Addendum 82: Regulation No. 83

Revision 4 – Amendment 1

Supplement 1 to the 06 series of amendments - Date of entry into force: 23 June 2011

Uniform provisions concerning the approval of vehicles with regard to the emission of pollutants according to engine fuel requirements

Paragraph 6.1.3., amend to read:

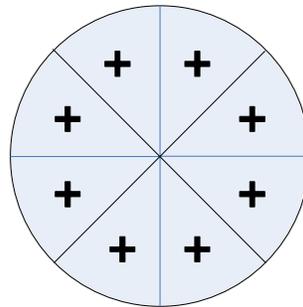
"6.1.3. A current of air of variable speed shall be blown over the vehicle. The blower speed shall be within the operating range of 10 km/h to at least 50 km/h or within the operating range of 10 km/h to at least the maximum speed of the test cycle being used. The linear velocity of the air at the blower outlet shall be within ± 5 km/h of the corresponding roller speed within the range of 10 km/h to 50 km/h. At the range over 50 km/h, the linear velocity of the air shall be within ± 10 km/h of the corresponding roller speed. At roller speeds of less than 10 km/h, air velocity may be zero.

The above mentioned air velocity shall be determined as an averaged value of a number of measuring points which

- (a) For blowers with rectangular outlets are located at the centre of each rectangle dividing the whole of the blower outlet into 9 areas (dividing both horizontal and vertical sides of the blower outlet into 3 equal parts).
- (b) For circular blower outlets, the outlet shall be divided into 8 equal arcs by vertical, horizontal and 45° lines. The measurement points lie on the radial centre line of each arc (22.5°) at a radius of two thirds of the total (as shown in the diagram below).

Paragraph 3.4.2., amend to read:

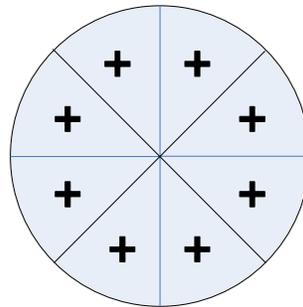
"3.4.2. A current of air of variable speed shall be blown over the vehicle. The blower speed shall be, within the operating range of 10 km/h to at least 50 km/h or within the operating range of 10 km/h to at least the maximum speed of the test cycle being used. The linear velocity of the air at the blower outlet shall be within ± 5 km/h of the corresponding roller speed within the range of 10 km/h to 50 km/h. At the range over 50 km/h, the linear velocity of the air shall be within ± 10 km/h of the corresponding roller speed. At roller speeds of less than 10 km/h, air velocity may be zero.

The above mentioned air velocity shall be determined as an averaged value of a number of measuring points which:

- (a) For blowers with rectangular outlets are located at the centre of each rectangle dividing the whole of the blower outlet into 9 areas (dividing both horizontal and vertical sides of the blower outlet into 3 equal parts).
- (b) For circular blower outlets, the outlet shall be divided into 8 equal arcs by vertical, horizontal and 45° lines. The measurement points lie on the radial centre line of each arc (22.5°) at a radius of two thirds of the total (as shown in the diagram below).
